RE: Contract #15025 PO0
(Silver) Leeds Certified Green Building – Eastern Family Resource Center
9150 Franklin Square Drive, Baltimore, Maryland 21237
Rosedale – District 14 c 6
Job Order No. 249-218-0100-0614

ADDENDUM NO. 3

ADDENDUM 03

BID SET 07/24/2015	
SHEET DESIGNATION	CONTRACT NO.
E5.04	15025P00
JOB ORDER NO.	
249-218-0100-0614	
SHEET OF	
DRAWING NO.	
2015-1998	
FILE NO.

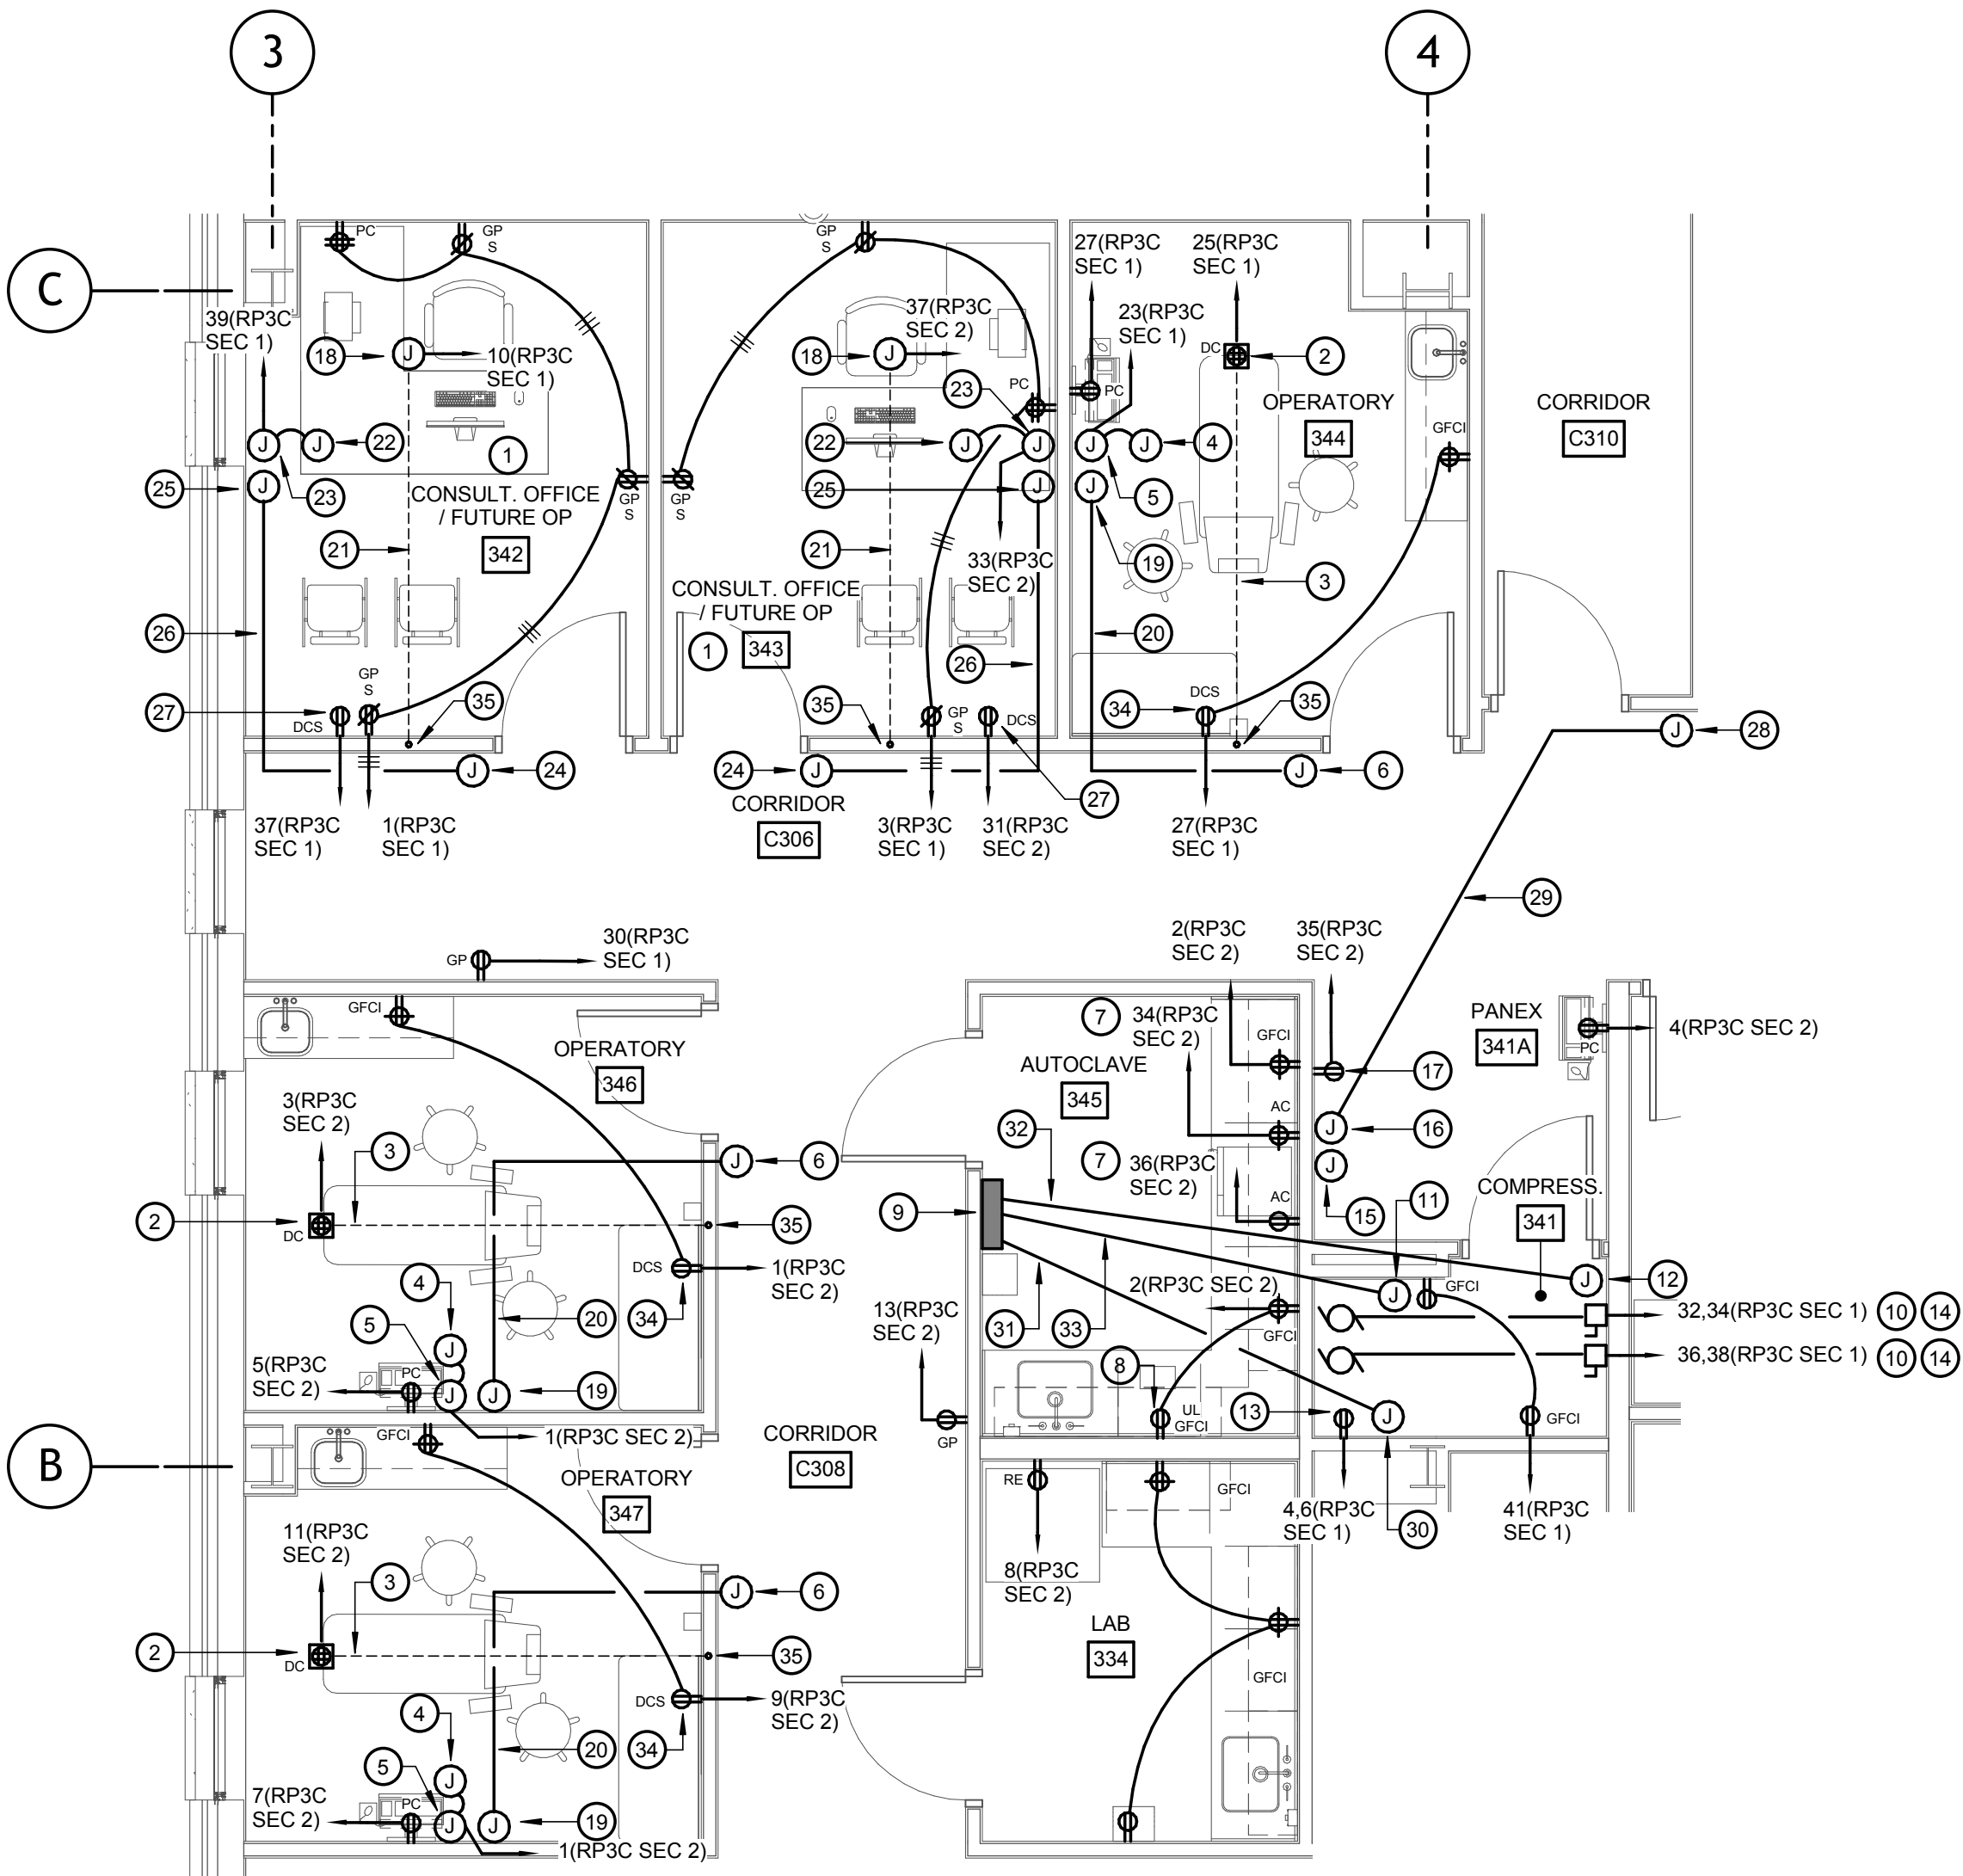
- 1 50% OF PRIVATE OFFICE RECEPTACLES SHALL BE AUTOMATICALLY (ON/OFF) CONTROLLED VIA THE LIGHTING CONTROL SYSTEM. PROVIDE UNSWITCHED HOT CONDUCTOR TO UNSWITCHED RECEPTACLE(S). PROVIDE SWITCHED HOT CONDUCTOR ROUTED THROUGH LIGHTING CONTROL SYSTEM POWER/RELAY PACK TO SWITCHED RECEPTACLE(S). REFER TO LIGHTING PLANS FOR ADDITIONAL INFORMATION.

- 2 POWER CONNECTION FOR DENTAL CHAIR. PROVIDE QUAD RECEPTACLE LOCATED WITHIN DENTAL CHAIR UTILITY CENTER ON 3rd FLOOR. ROUTE CIRCUIT FROM 2nd FLOOR ACCESSIBLE CEILING SPACE UP INTO DENTAL CHAIR UTILITY CENTER. COORDINATE FINAL REQUIREMENTS WITH DENTAL EQUIPMENT PROVIDER/INSTALLER.
